Re: Florida Power & Light Company
Proposed Turkey Point Units 6 and 7
Docket Nos. 52-040 and 52-041
Groundwater Flow Model Revision 6

L-2012-366
10 CFR 52.3

Table 1
Groundwater Model Development and Analysis Report (Rev. 2) Change Description

Figure 21. Cooling Canals Water Balance

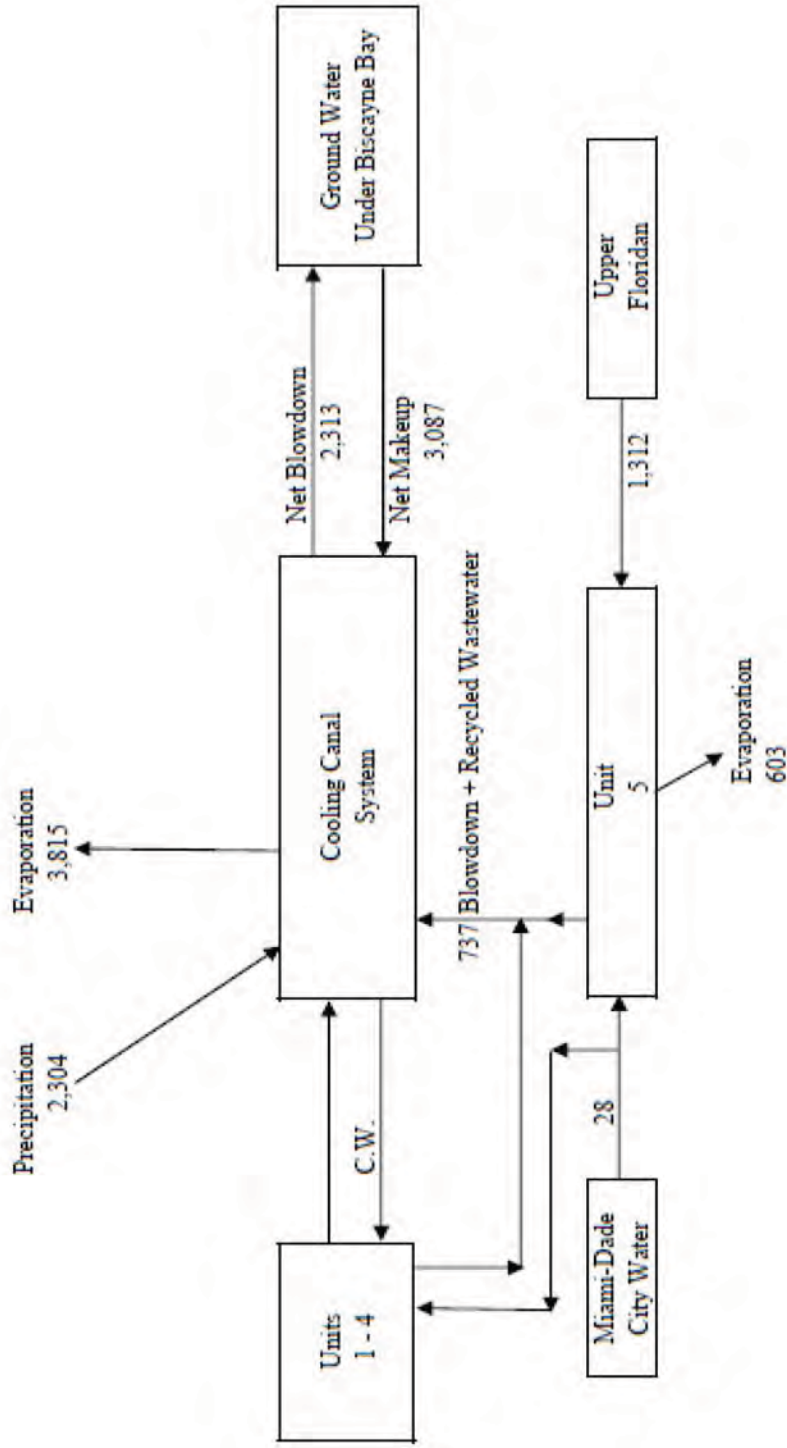
Figure 21	Revision 1 flow diagram had two Post – EPU values, for Revision 2, changed to Pre – EPU values.
Figure 33	Revision 1 included the RCW laterals which should not be shown since figure is for pre-RCWs condition. For Revision 2, removed laterals and added footnote pointing to Figure 55 for location of RCW laterals.
Figures 37 through 44	Contours revised as the result of the corrected GHB conductance.
Figure 45	Revision 1 had a Post – EPU value, for Revision 2, changed to Pre – EPU value. Slight changes to the modeled values and percentages as the result of the corrected GHB conductance.
